SERVICE BULLETIN

RECOMMENDED No. 05.96

SUBJECT : TIME LIMITS / MAINTENANCE CHECKS
 Modification and Monitoring of the Tightening Torque of the Splined Bush Attachment Bolts on the Main Rotor Hub.

Corresponds to MOD 072323

FIGURE 1

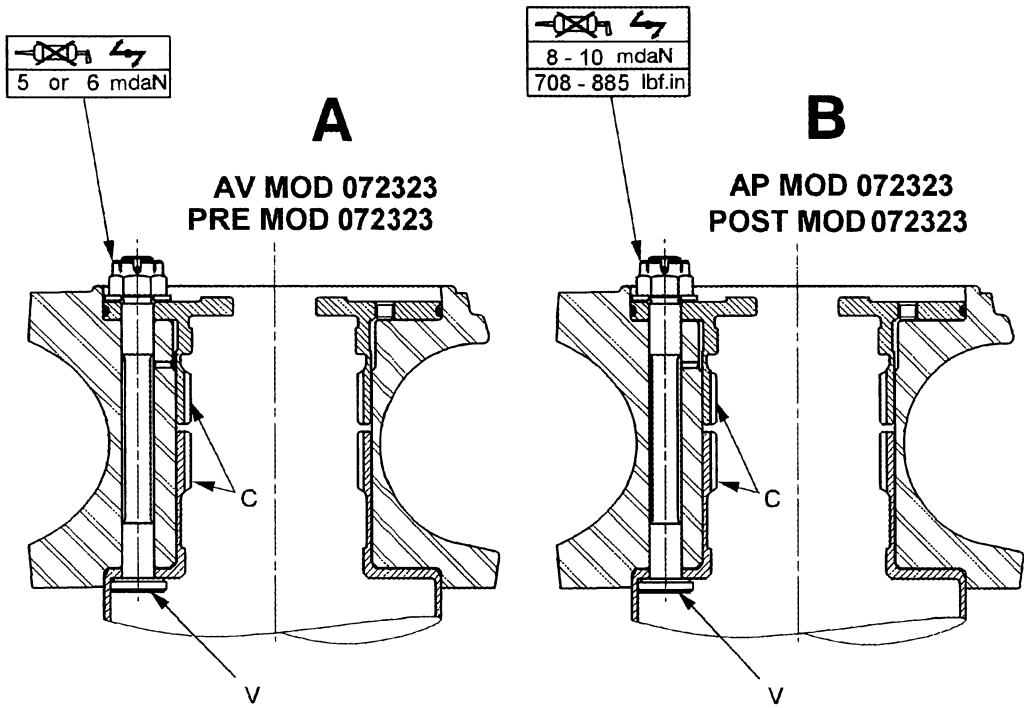
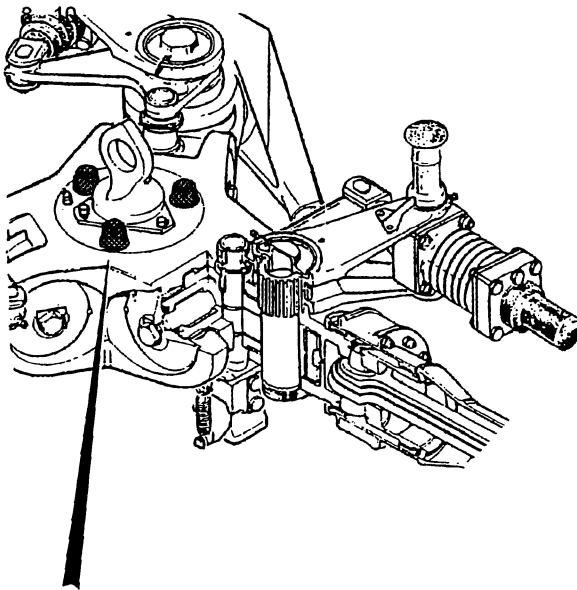
1. Increase in the tightening torque of the 3 bolts (V) which secure splined bushes (C)
(as per FIGURE 1, View A), (corresponds to MOD 072323).

- Remove the MRH as per work card 57.20.401 or 57.2.401.
- Remove bolts (V) (remove and check the bolts one by one).
- Check for possible cracks as per (MTC 20.02.09.101 or 20.02.09.102), using dye penetrant inspection or magna flux inspection, especially in the bolt head-to-bolt shaft connection area.

NOTE : Any bolt affected by a crack is to be scrapped and replaced with a new bolt, see paragraph 3.B.

- Fit bolts (V) (checked or new) which secure the splined bushes.
- Apply new dry tightening torque of 8 to 10 m.daN (as per FIGURE 1, View B).
- Install the MRH as per work card 57.20.401 or 57.2.401.

2. Readjustment of the tightening torque of the 3 bolts (V) which secure splined bushes (C)
(as per FIGURE 1, View B).

Adjust the dry tightening torque to 8 to 10 m.daN as per MTC 20.02.05.404, paragraph 1.2.2.
